## S E R V I C E N O T E

### E1446A C-Size VXI Summing Amplifier/DAC

**Serial Numbers:** 3223A00101 / 3223A00192

**Modification to prevent output from sticking at the +24 VDC or -24 VDC rail.**

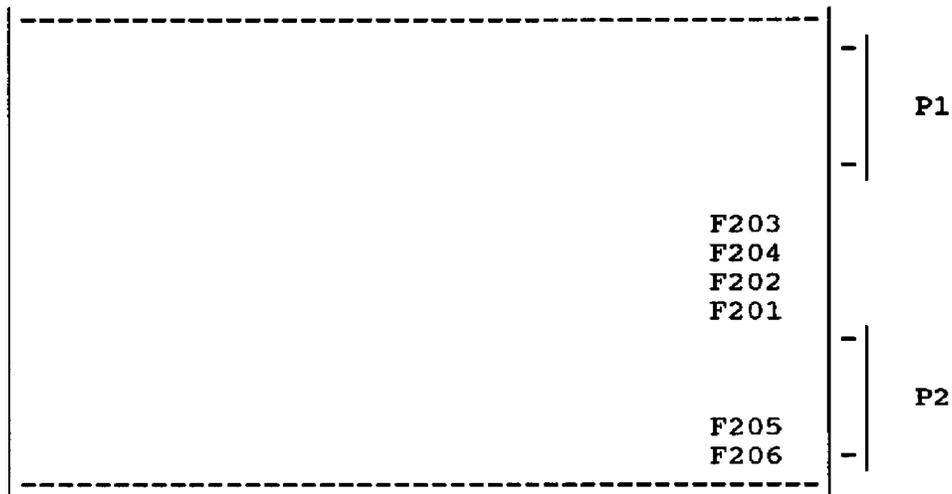
When the E1446A is used in some VXI C-size mainframes (particularly the E1401A), occasionally one of the E1446A fuses in the + and -24 VDC supply lines (F205 and F206) may open when power is applied to the mainframe. The E1446A appears to have some inrush current at power-up that occasionally exceeds the time/current rating of the existing 1 Amp fuses.

The symptom of the open-fuse condition is when the output of the E1446A sticks at either the +24 VDC or the -24 VDC supply rail.

When the symptom described above occurs, replace all six of the E1446A on-board power supply fuses (F201-F206) with fuse p/n 2110-0699 as follows:

1. Remove the top shield from the E1446A:
  - a. Loosen (but do not remove) the locking nuts on the five BNC connectors on the front panel.
  - b. Remove the seven T10 torx screws holding the shield to the PC board.
2. Orient the PC board with the connectors to the right. Locate the ERC code label in the lower L/H corner. If the ERC code is smaller than 3313, proceed to step 3 below. If the ERC code is 3313 or greater, this E1446A has already received the modification described in this service note. Check the fuse (F201-F206) for continuity and replace any fuse that is open. Reassemble the units and test. If the output is still stuck at + or -24 VDC, the fuse has probably opened again. Replace the whole module with an exchange assembly (p/n E1446-69201).
3. Replace all 1 A fuses (F201-F206) with 5 A fuses (p/n 2110-0699).
